Heathcote Road bridge widening

Submissions report

Transport for NSW | June 2021

Figure 2-3 Recently completed or planned projects along Heathcote Road (Transport for NSW, 2020c)

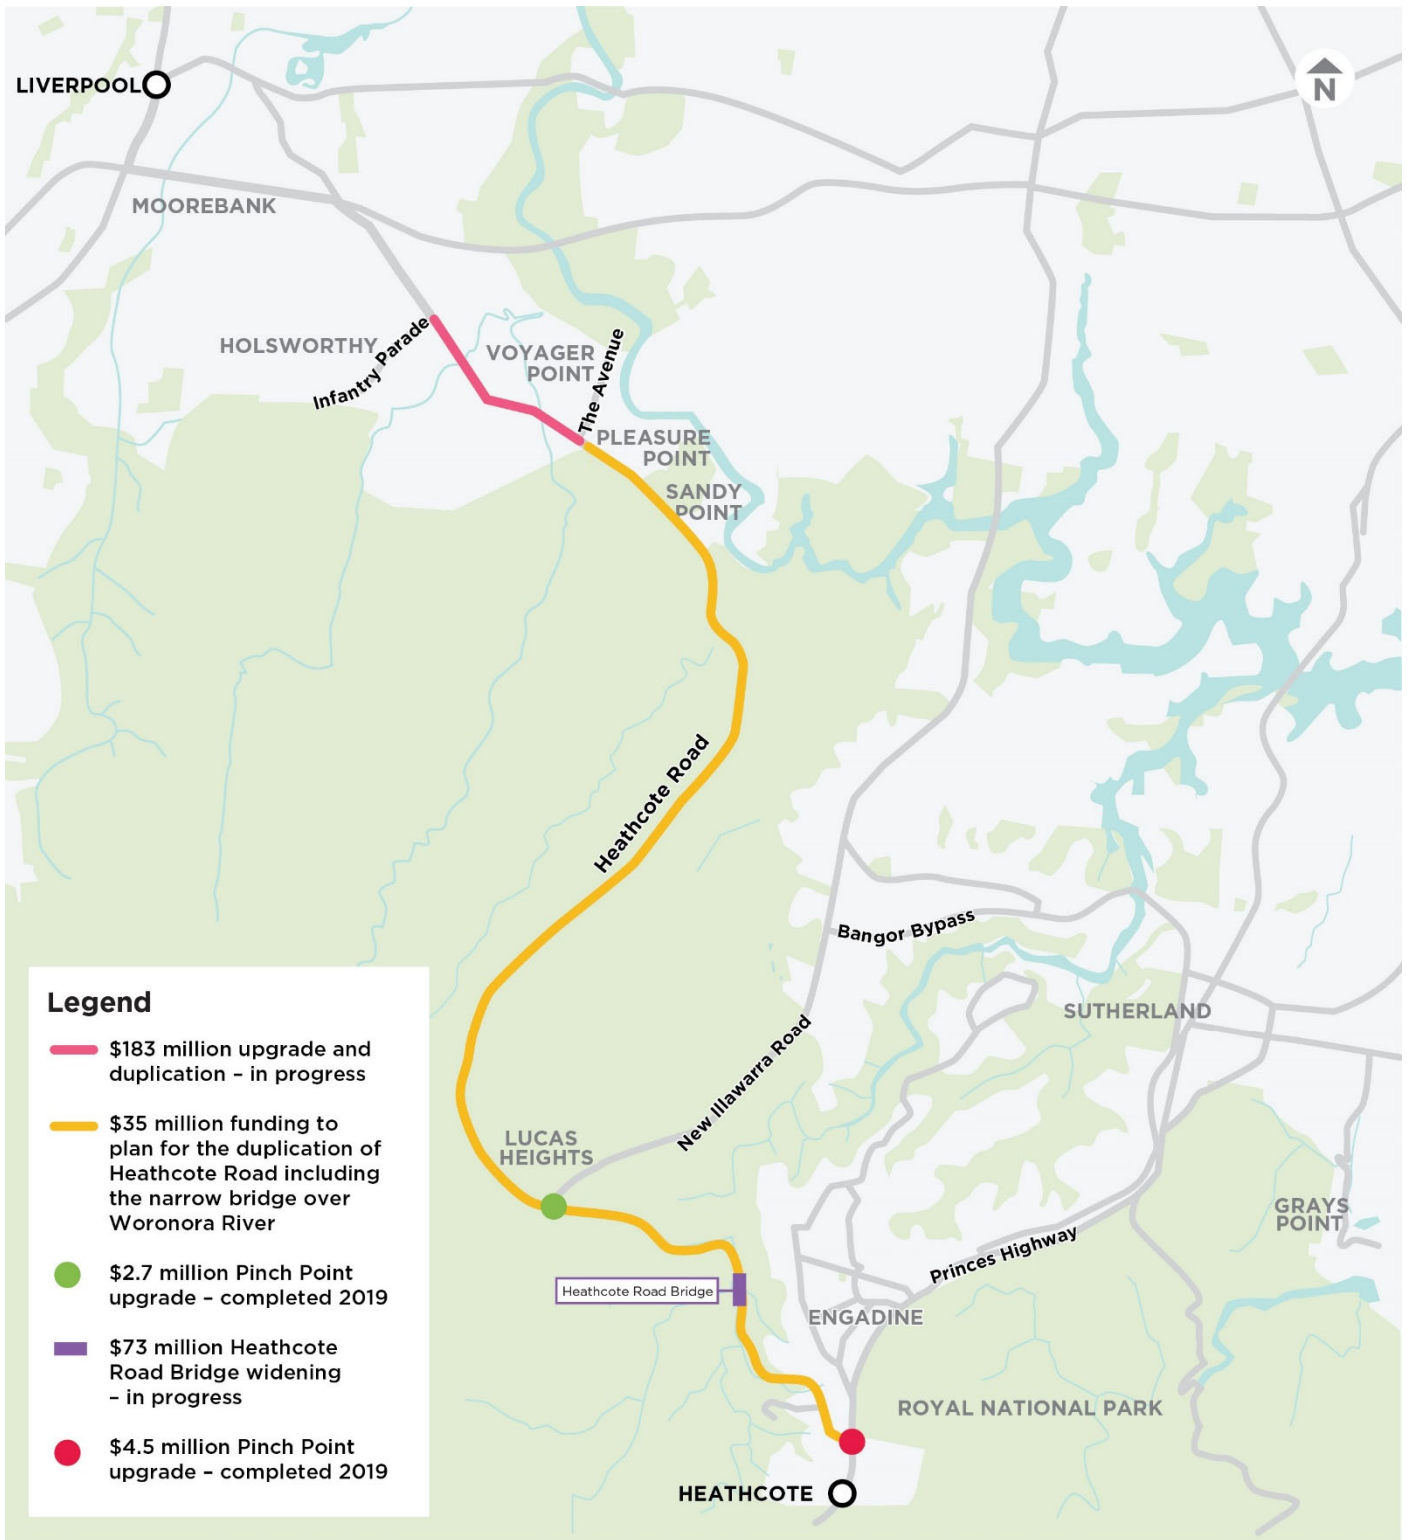
- suggestions to review opportunities to provide additional measures for fauna connectivity (particularly focusing on koalas) at several other locations along the Heathcote Road corridor that have records of fauna roadkill such as the underpasses at Harris Creek, Williams Creek and Deadmans Creek at Sandy Point

- suggestion that providing additional fauna connectivity measures at other locations along Heathcote Road at the same time as the Heathcote Road bridge widening construction would provide value as road closures would already be in place and procurement for equipment could be done at the same time.

Table 2-1 and Figure 2-3 presents a summary of nearby road upgrade projects that are ongoing or have been recently completed by Transport for NSW within the surrounding road corridor, which includes several improvements along Heathcote Road.
